Date	Expiration	Release	Page
11.2013	11.2014	1	1(3)

COOLANT FAN BELT REPLACEMENT WITH NEW SEVERE DUTY Prevost vehicles

FIGURE 1: FAN BELT ROUTING (VOLVO D13 ENGINE)

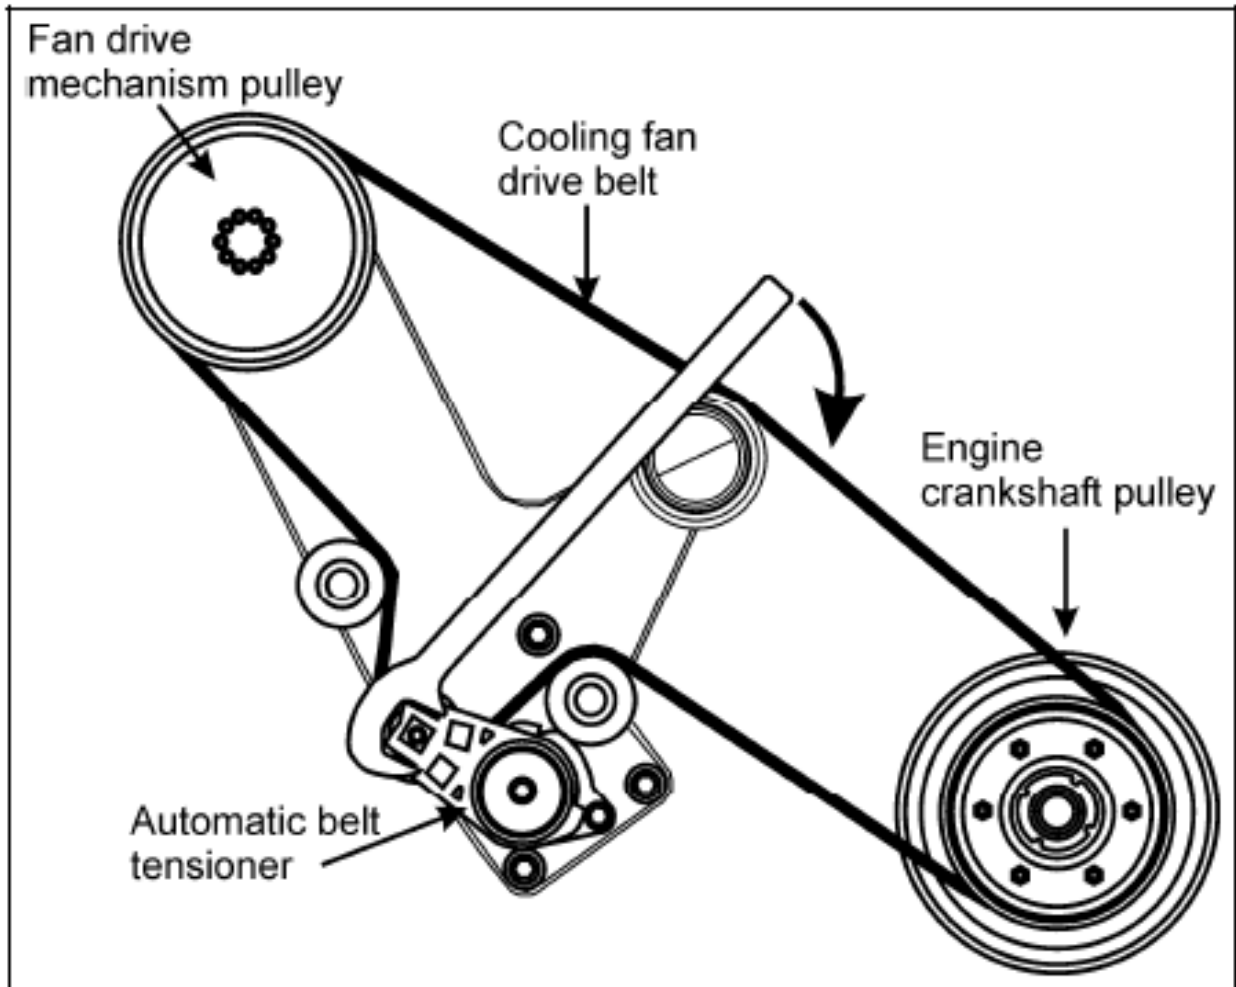
On the vehicles affected by this bulletin, it is possible to experience sudden coolant fan belt snapping due to excessive force applied to the belt. Therefore, it is necessary to replace the current belt (**part # 5061284**) with a new Severe Duty belt (**part # 5060119**)

1. Using the special tool included with your vehicle (see inside the Warning Reflectors box located in the first curb-side baggage bay), rotate the automatic tensioner in clockwise direction to relieve tension on the belt and hold the tensioner in that position (Fig.1).
2. Remove the old belt from the pulleys.
3. Wrap the new drive belt around the fan drive mechanism pulley, the idlers and the automatic tensioner idler as shown on figure 1.
4. Release the tensioner slowly and let it return to its natural position, no further adjustment is required.
